10/553,457

<b>Office Action Summary</b>	<b>Application No.</b> 10/553,457	<b>Applicant(s)</b> BOHM ET AL.	
	<b>Examiner</b> DNYANESH KASTURE	<b>Art Unit</b> 4147

## **DETAILED ACTION**

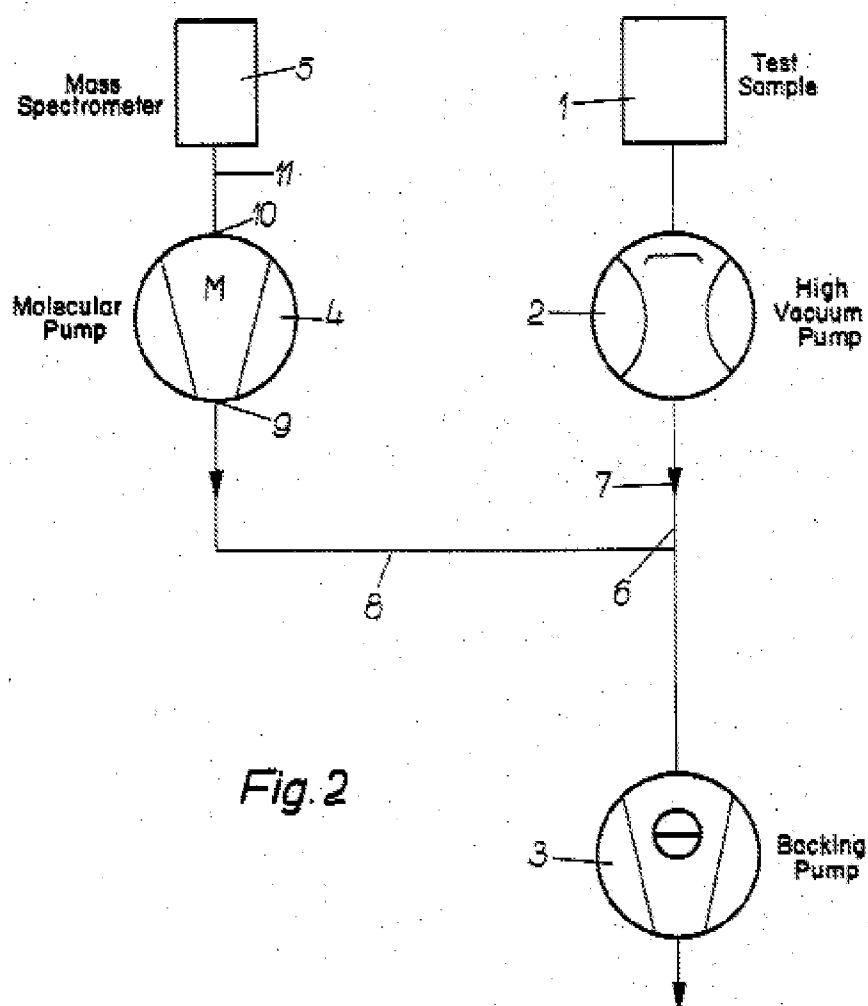
8. In Re claim 5, with reference to Figure 2 depicted above, Becker discloses a Leak detector (column 1, line 15) comprising:

- a first high vacuum pump (2) having an entry side which is inherently connected to an inlet of the leak detector (1)
- a second high vacuum pump (4) having an entry side which is connected to a mass spectrometer (5)
- a primary pump (3) having an entry side which is connected to the exit sides (9) and (7) of the first (2) and second (4) high vacuum pumps by conduits (6) and (8)
- there are no throttles or valves between the means connecting the first high vacuum pump (2) and the inlet of the leak detector (1)

9. However, Becker does not disclose a bypass with a first valve and a second valve between the first high vacuum pump and the primary pump.

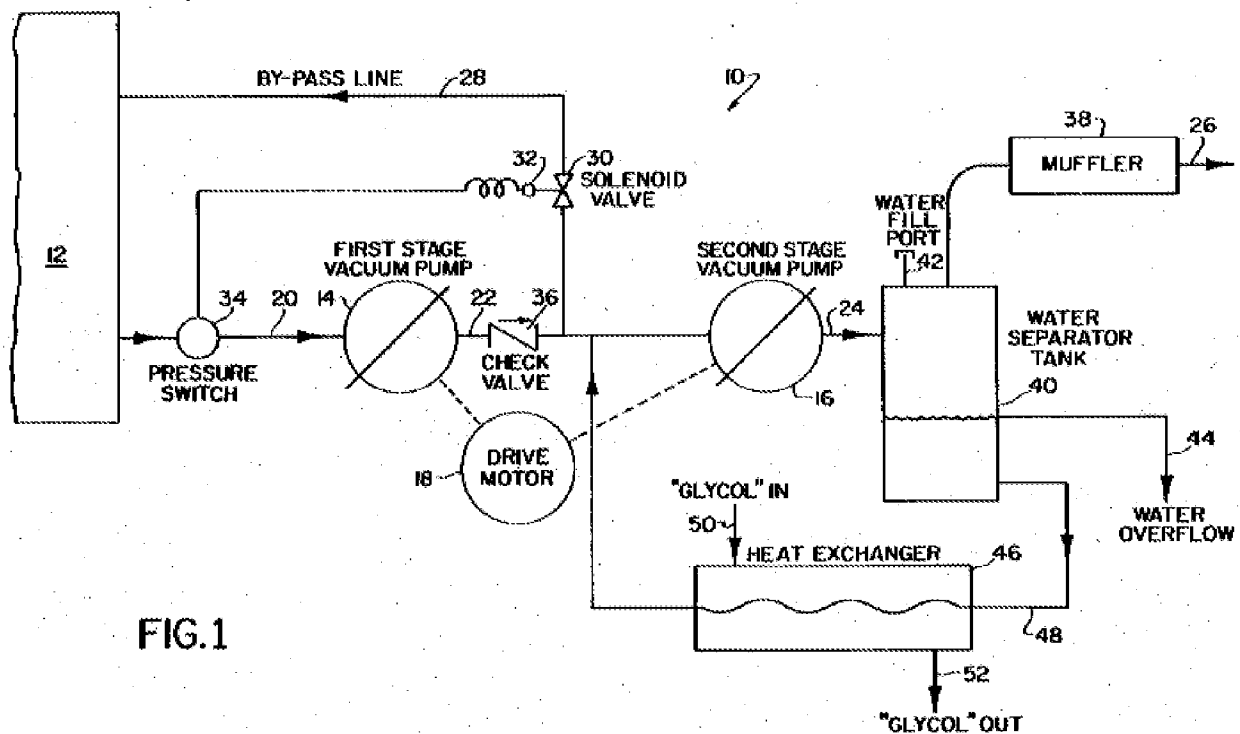
10. Nevertheless, with reference to Figure 1 depicted above, Alloca et al discloses a vacuum pumping system comprising:

- a first high vacuum pump (14) having an entry side which is inherently connected to a vacuum chamber (12) in a non-throttled manner without valving
- a bypass (28) with first valve (30) connecting vacuum chamber (12) to the primary pump (16)
- a second valve (36) provided between the exit side of the first high vacuum pump (14) and a primary pump (16)

11. It would have been obvious to a person having ordinary skill in the art at the time of the invention to:

- modify the leak detector of Becker to include a bypass line with a first valve connecting the inlet of the leak detector to the primary pump as taught by Alloca et al for the purpose of relieving interstage pressure, thereby lowering the power draw on the drive motor as taught by Alloca et al as stated in column 2, line 67 to column 3 line 2.
- further modify the leak detector of Becker to include a second valve provided between the exit side of the first high vacuum pump and a primary pump as taught by Alloca et al for the purpose of preventing back pressure on the first high vacuum pump as taught by Alloca et al as stated in column 3, lines 20-21.

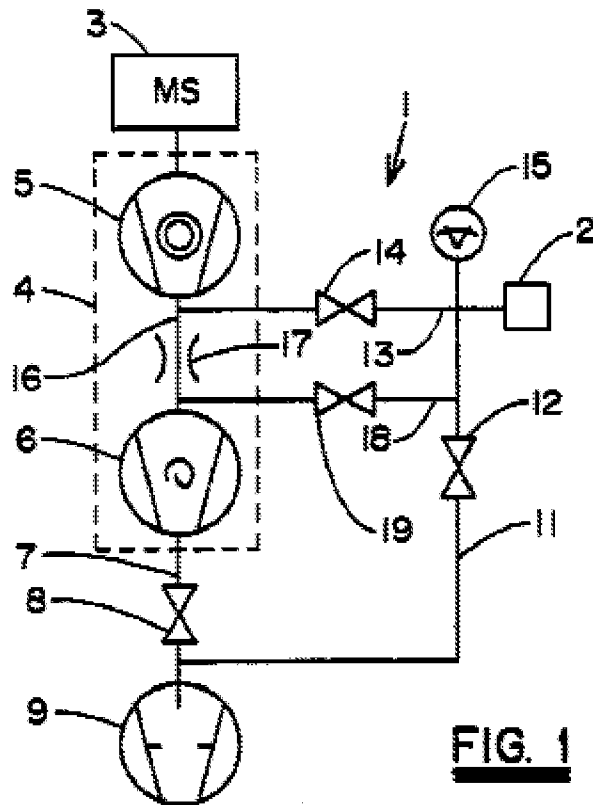
14. However, with reference to Figure 1 depicted above, Grosse Bley et al discloses a leak detection unit (1) comprising:

- a second high vacuum pump (4) with two stages (5) and (6)
- intermediate inlet (13) with valve (14)

- intermediate inlet (18) with valve (19)
- valves (14) and (19) are initially closed, and are “controlled” by opening them once forevacuum pressure ("pressure on the exit side") has been attained (see column 3, lines 29-36)

15. It would have been obvious to a person having ordinary skill in the art at the time of the invention to further modify the Leak detector in Becker modified by Alloca et al, as applied to claim 5, to include the intermediate inlets and valves from the second high vacuum pump as taught by Grosse Bley et al for the purpose of increasing the sensitivity of leak detection as taught by Grosse Bley et al as stated in Column 3, line 37.

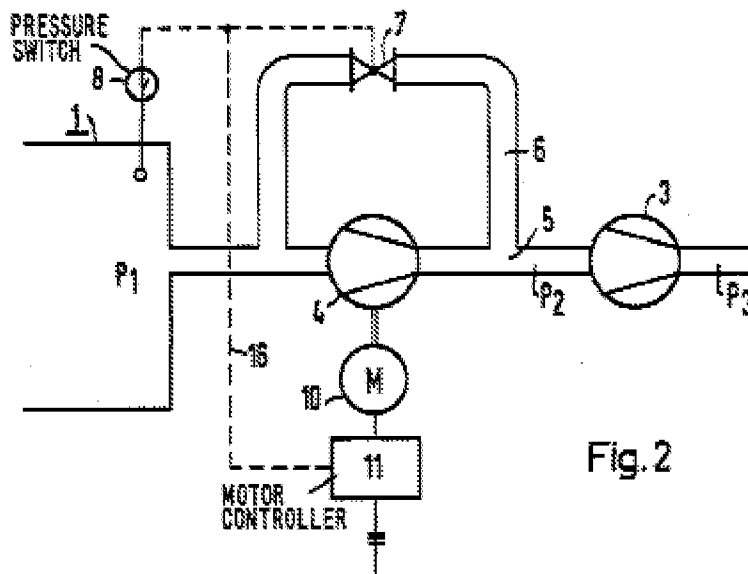
19. Nevertheless, with reference to Figure 2 depicted above, Mugele et al discloses a pump set comprising:

- a first high vacuum pump (4) having an entry side which is inherently connected to a vacuum chamber (1) in a non-throttled manner without valving
- a bypass (6) with first valve (7) connecting vacuum chamber (1) to the primary pump (3)

20. It would have been obvious to a person having ordinary skill in the art at the time of the invention to modify the leak detector of Becker to include a bypass line with a first valve connecting the inlet of the leak detector to the primary pump as taught by Mugele et al for the purpose of avoiding inadmissibly high power consumption as taught by Mugele et al as stated in column 3, line 22.

24. In Re claim 7, Mugele et al discloses in column 3, lines 14-22 that the first high vacuum pump (4) is activated by starting motor (10) when the pressure has reduced below a "limit value" of 40 Torr, after the first valve (7) has been opened enabling the primary pump (3) to achieve a sufficient vacuum.
